Approved Section 96 (1A) (1) (2) Modification Application

Revision 04 - Section 96 Amendments

Site 68
Sydney Olympic Park

Plan
Basement Level B1

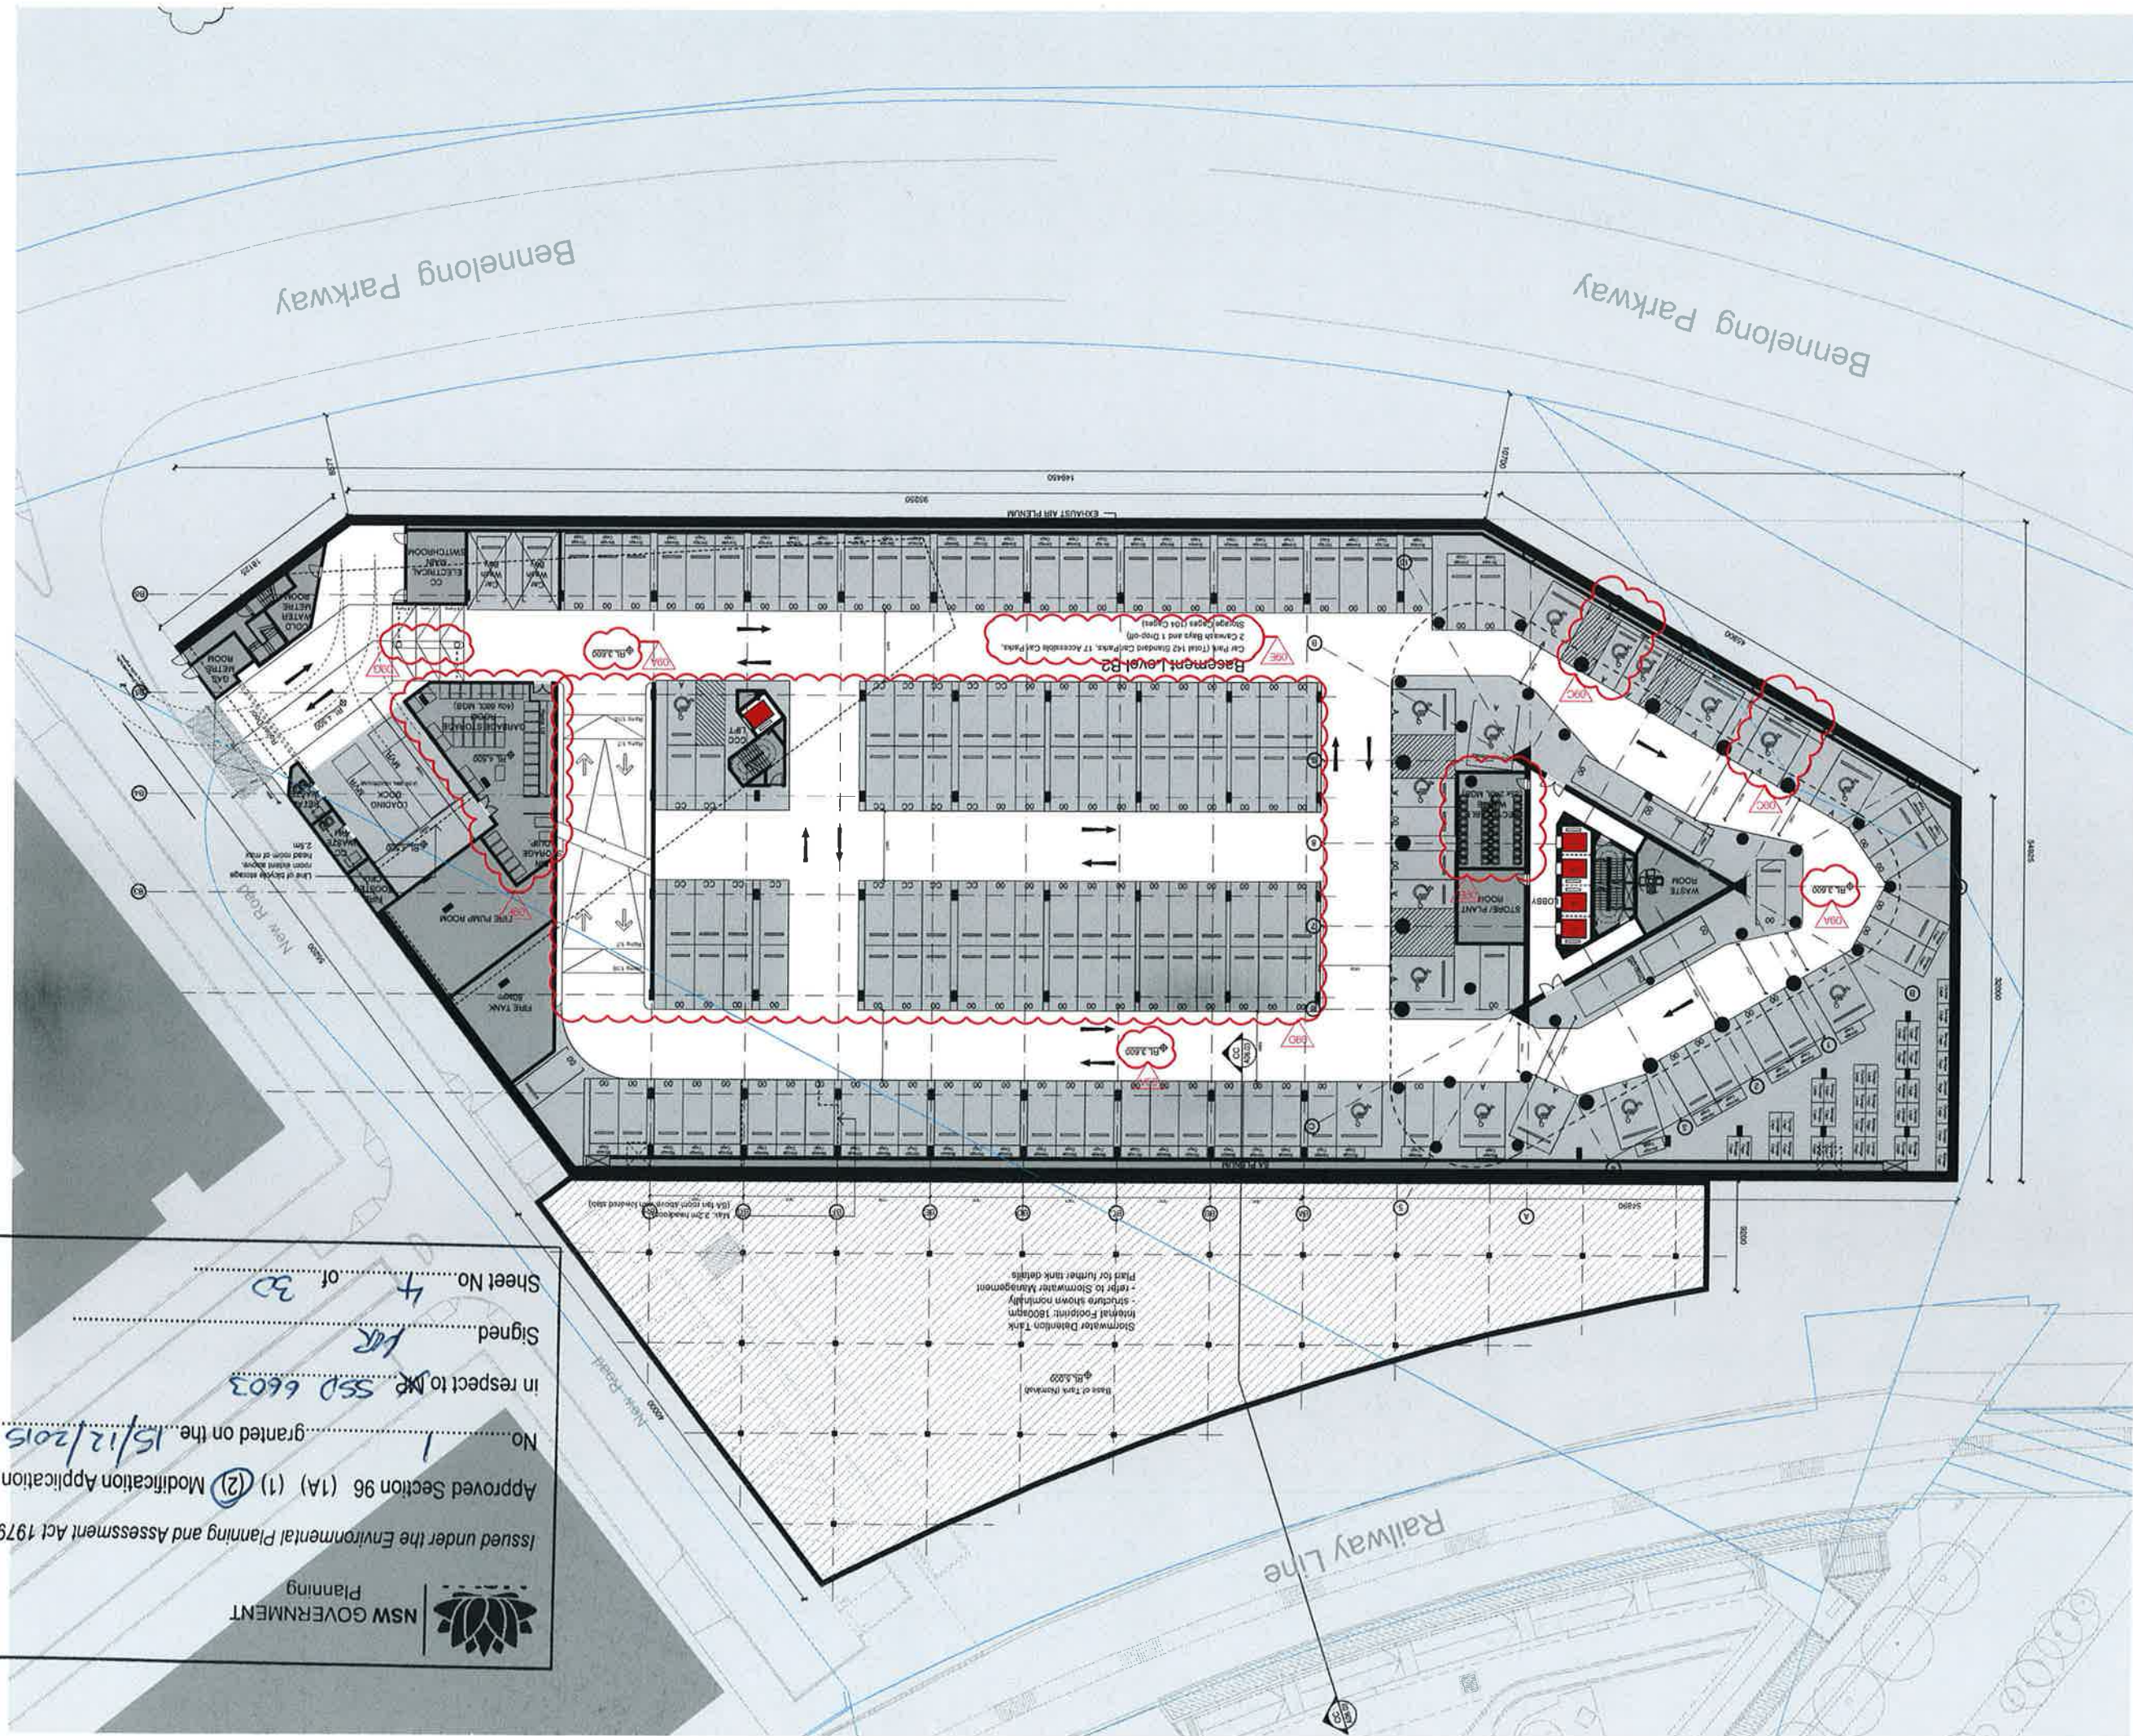
A - Accessible car space converted to conventional space.
B - Divisarys enlarged from 61 to 68 bays due to increased unit count.
C - Conventional space converted to accessible space.
D - Car space drive aisles rotated by 90°. Ramp moved north.
E - Car parking count increased from 145 to 153 spaces.
F - Bike parking count increased from 156 to 259 spaces.

Site 68
Sydney Olympic Park
Basement Level B3

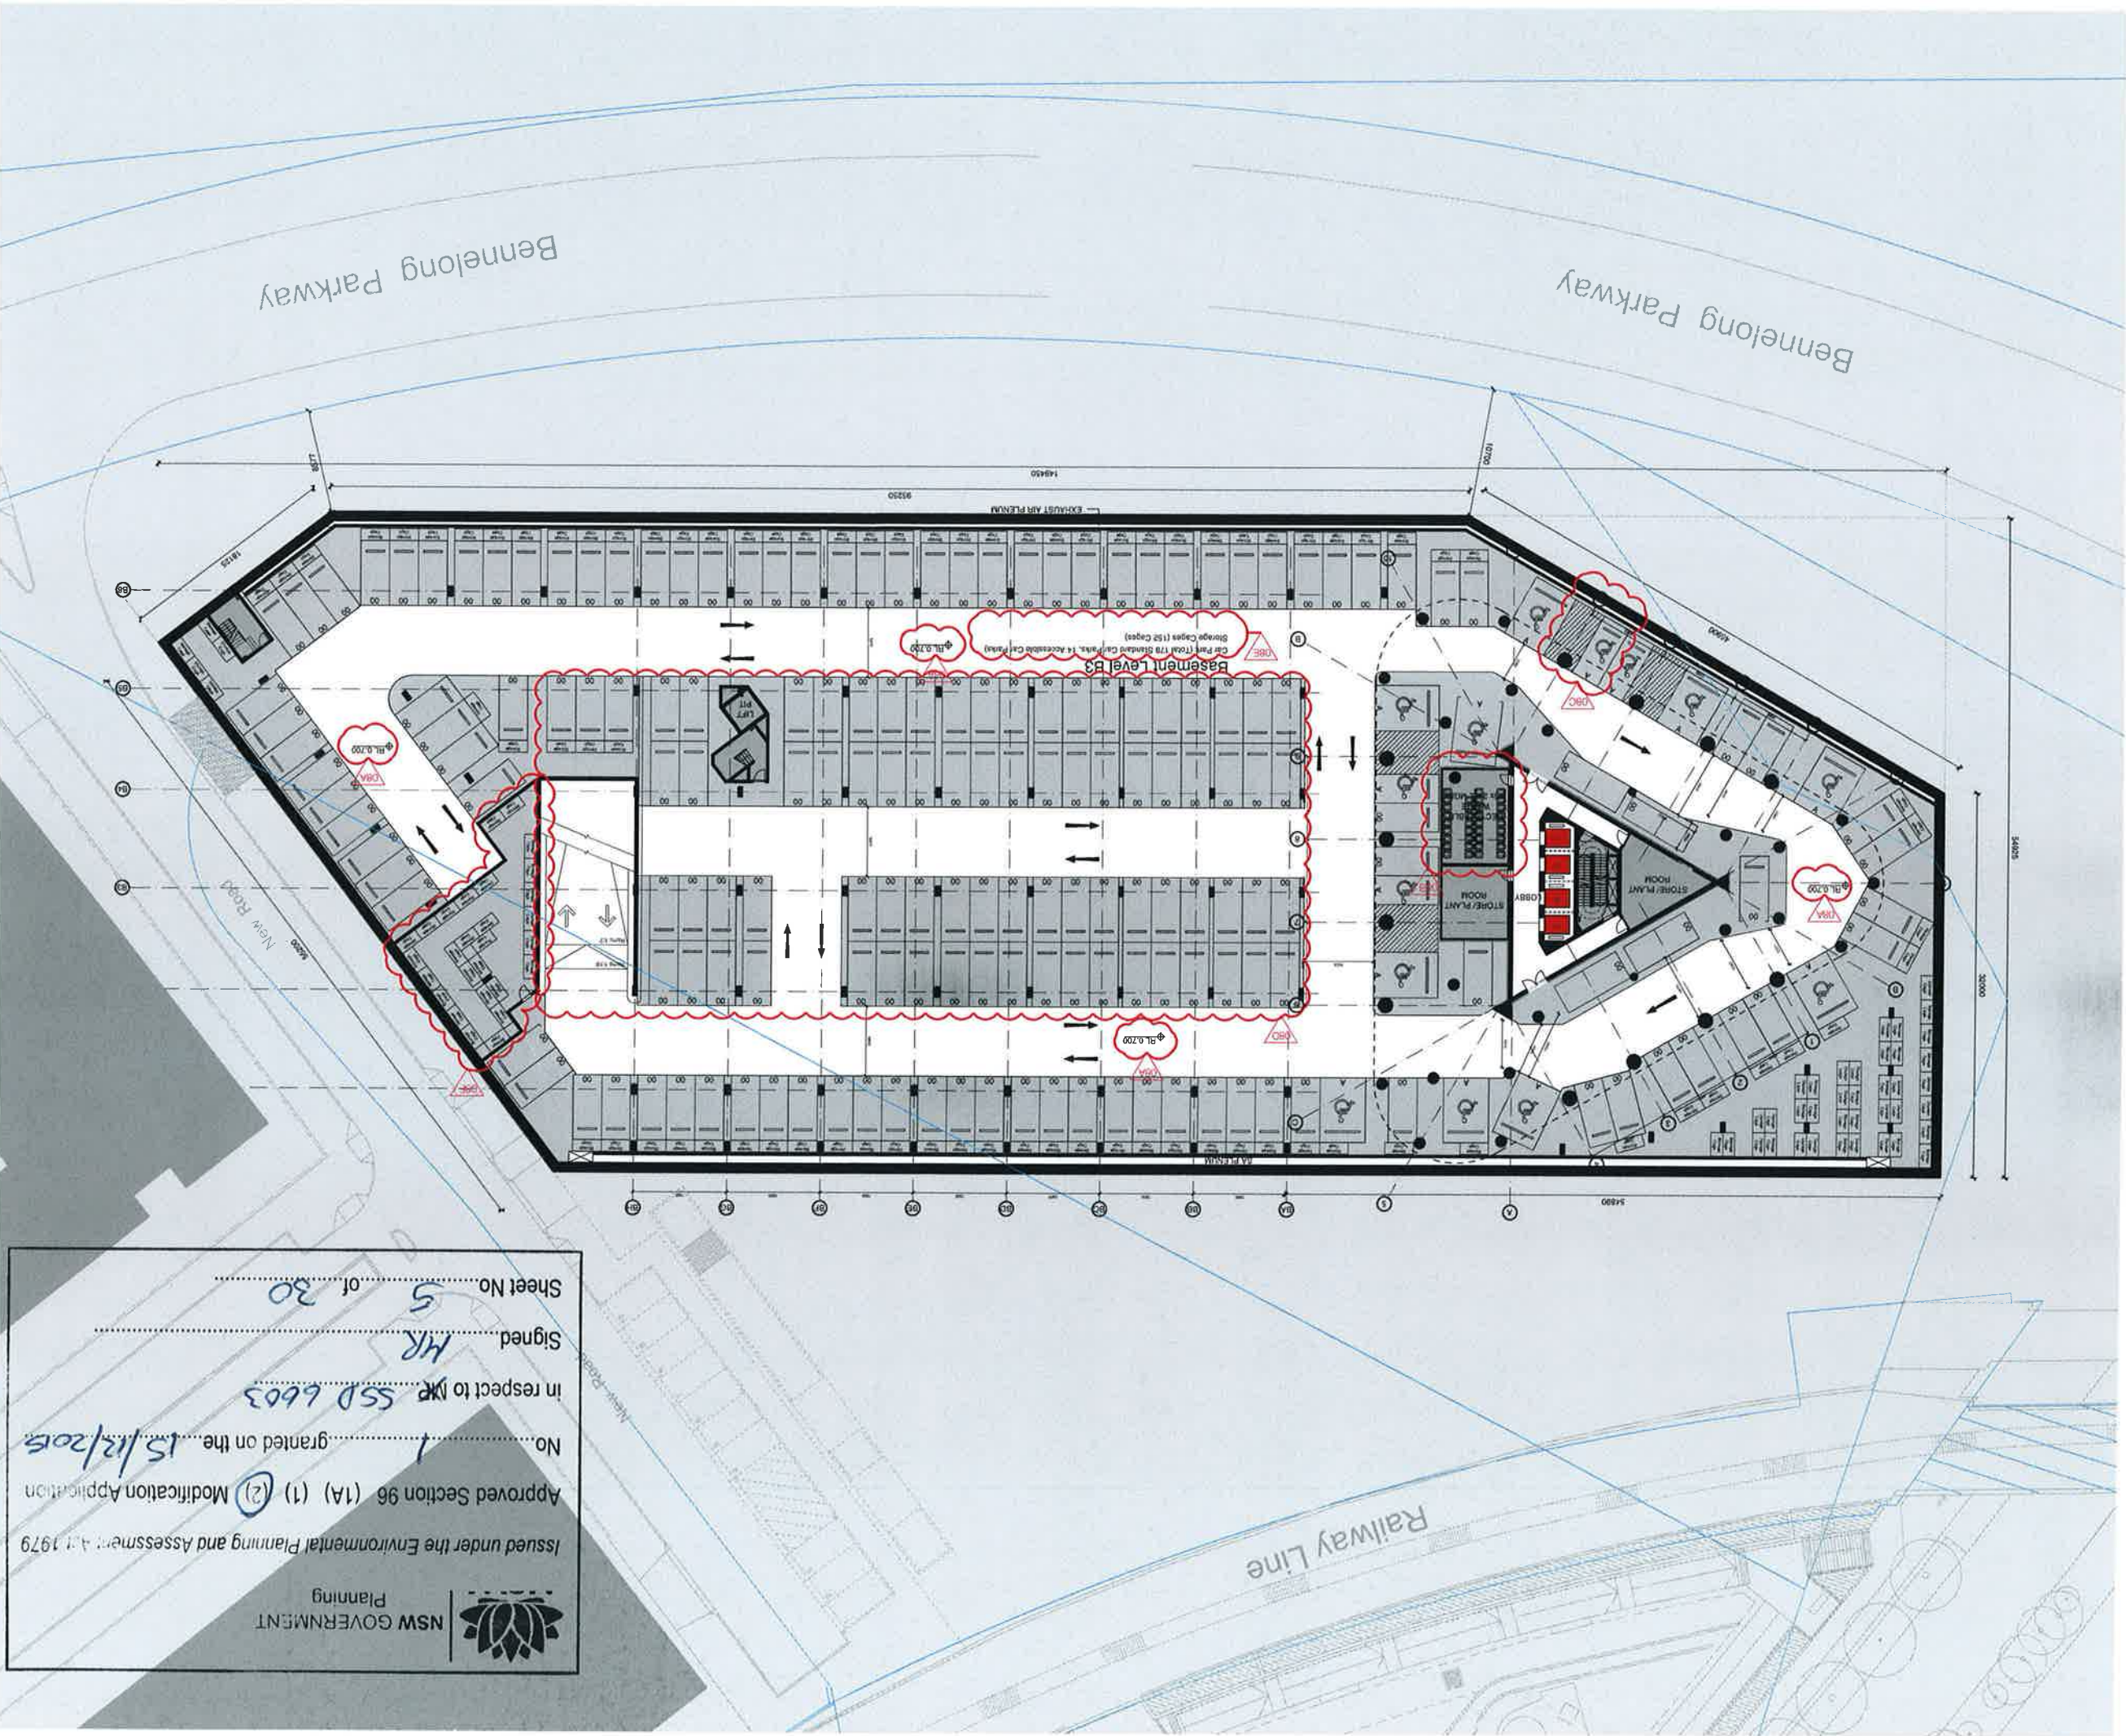
A - Refer to local height limits 32 & 33 which are from 2.0m to 2.5m.

B - Ben notes re-align from 33 to 34 have also in previous set out.

C - Circular road constructed to accurate space.

D - Car space drive access moved by 200mm to allow for 150mm.

E - Car parking court increased from 184 to 153 spaces.

F - Additional basement storage.

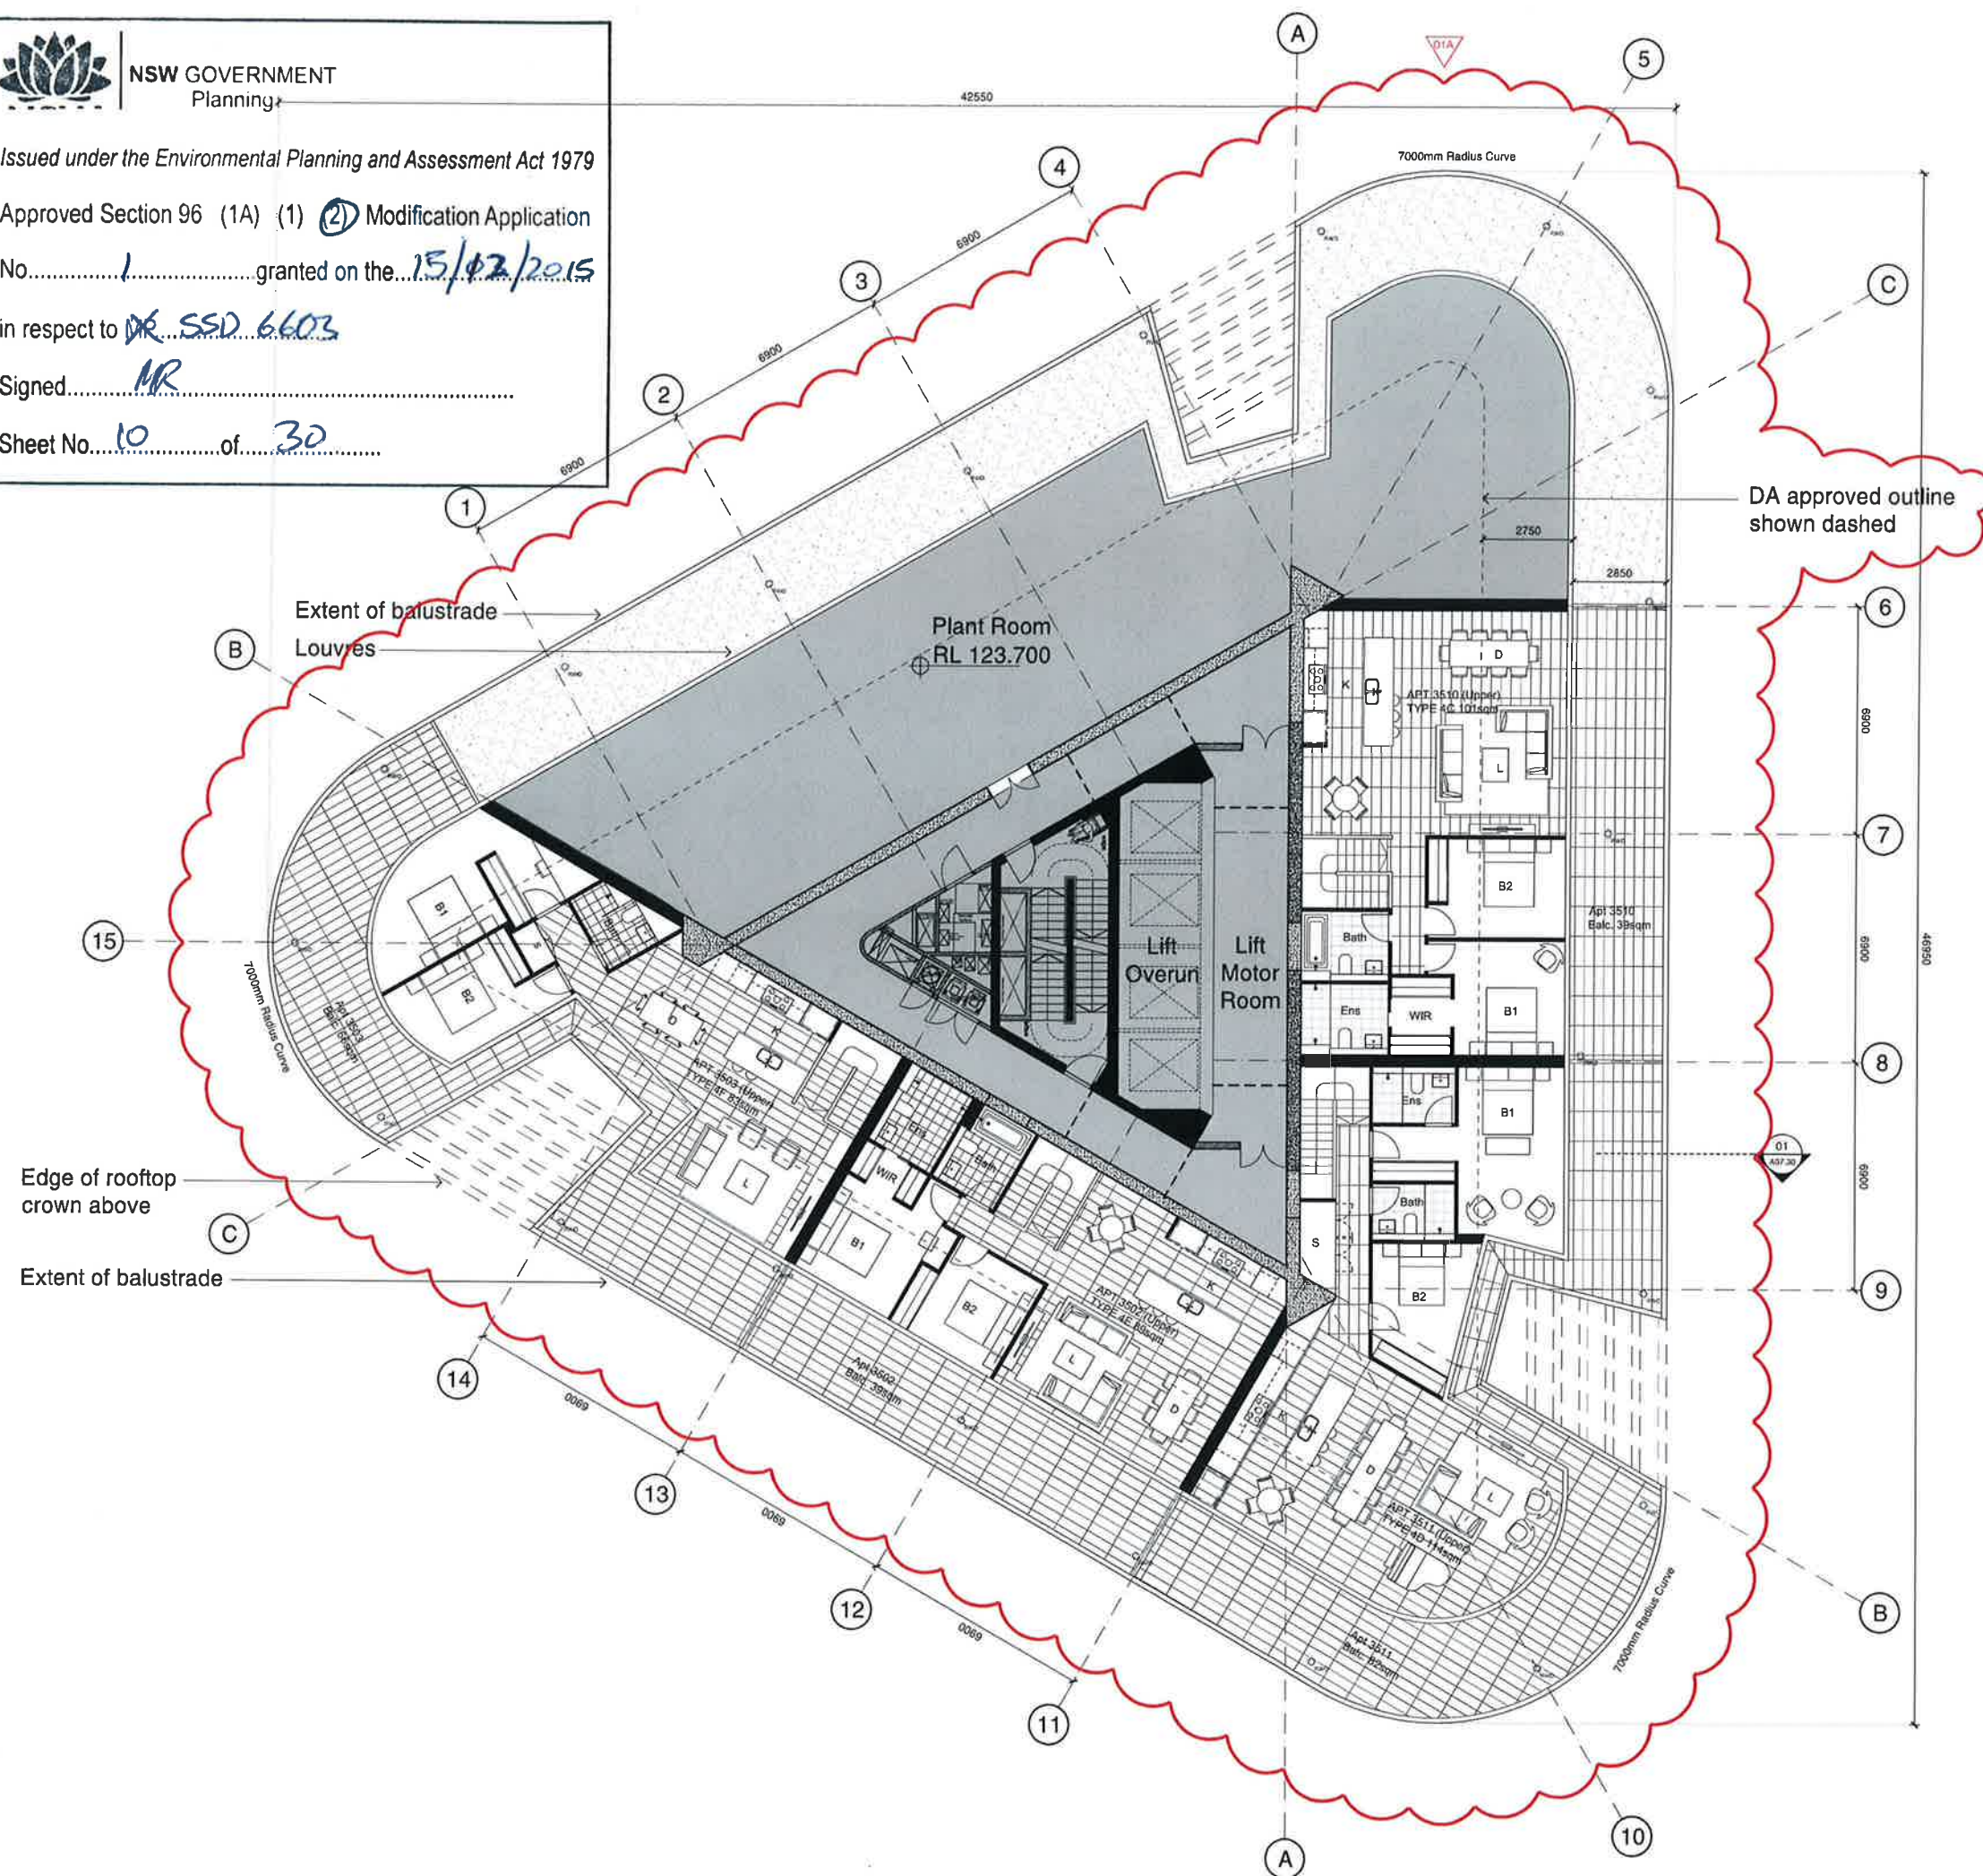
A - New Drawing, New residential floorplate
